EASA	NOTIFICATION OF A PROPOSAL TO ISSUE AN AIRWORTHINESS DIRECTIVE
	PAD No.: 14-103R1 Date: 08 July 2014 Note: This Proposed Airworthiness Directive (PAD) is issued by EASA, acting in accordance with Regulation (EC) No 216/2008 on behalf of the European Community, its Member States and of the European third countries that participate in the activities of EASA under Article 66 of that Regulation.
In accordance with the EASA Continuing Airworthiness Procedures, the Executive Director is proposing the issuance of an EASA Airworthiness Directive (AD), applicable to the aeronautical product(s) identified below. All interested persons may send their comments, referencing the PAD Number above, to the e-mail address specified in the 'Remarks' section, prior to the consultation closing date indicated.	
Type Approval Holder's Name : AIRBUS	Type/Model designation(s) : A318, A319, A320 and A321 aeroplanes

TCDS Number : EASA.A.064	
Foreign AD : Not applicable	
Supersedure: This AD supersedes EASA AD 2012-0055R1 dated 17 October 2012.	
ATA 35	Oxygen – Chemical Emergency Oxygen Containers – Modification
Manufacturer(s):	Airbus (formerly Airbus Industrie)
Applicability:	Airbus A318-111, A318-112

Appendix 1 – Design A of the Passenger Oxygen Containers affected by this AD

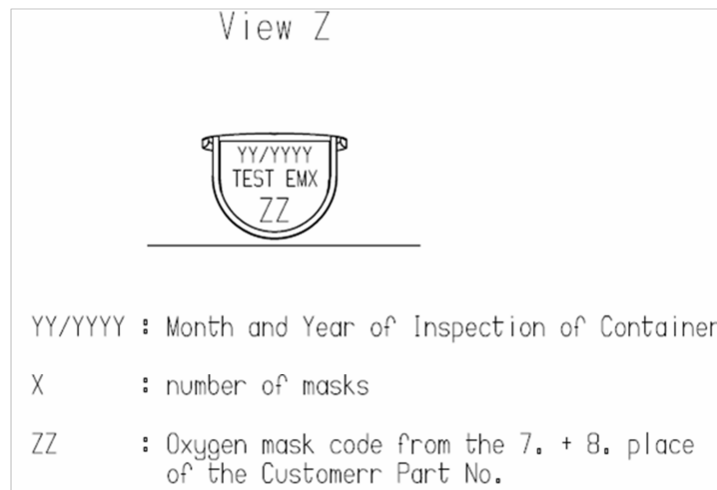
Design A: The placard on the passenger oxygen container test button is as described in Picture A of Appendix 1 of this AD. The Mask configuration ("ZZ" in Picture A) is a number and the test button is as shown in Picture B.
